Economic Commission for Europe**Inland Transport Committee****World Forum for Harmonization of Vehicle Regulations****Working Party on General Safety Provisions****116th session**

Awareness of the proximity of Vulnerable Road Users:**UN Regulation No. 46 (Devices for indirect vision)****Proposal for the 05 series of amendments to UN Regulation
No. 46 (Devices for indirect vision)****Submitted by the Informal Working Group on Awareness of
Vulnerable Road Users Proximity***

Figure 11
Class VIII field of vision

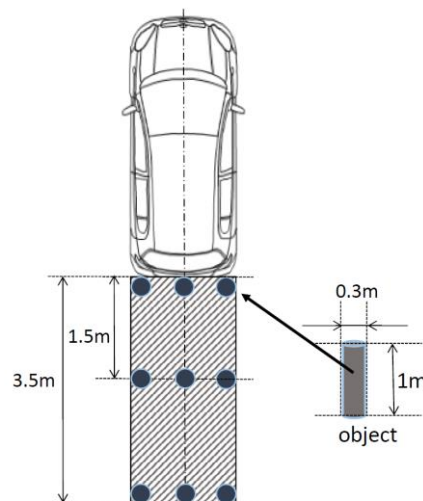
Insert new paragraphs 15.2.4.8. to 15.2.4.8.3., to read (inserting a new Figure 11):

- 15.2.4.8. Class VIII close-proximity rear-view device**
- 15.2.4.8.1. The field of vision shall be bounded by the following planes and shall be such that the driver can see at least part of each cylindrical objects with a height of 1,000 mm and a diameter of 300 mm which is located on the ground plane at nine positions within the boundaries of the field of vision as defined in Figure 11 below:**
- (a) **A transverse vertical plane through the outermost point of the rear of the vehicle;**

- (b) A transverse vertical plane [3,500] mm behind the outermost point of the rear of the vehicle;
- (c) Two longitudinal vertical planes parallel to the longitudinal vertical median plane going through the outermost point of each side of the vehicle.
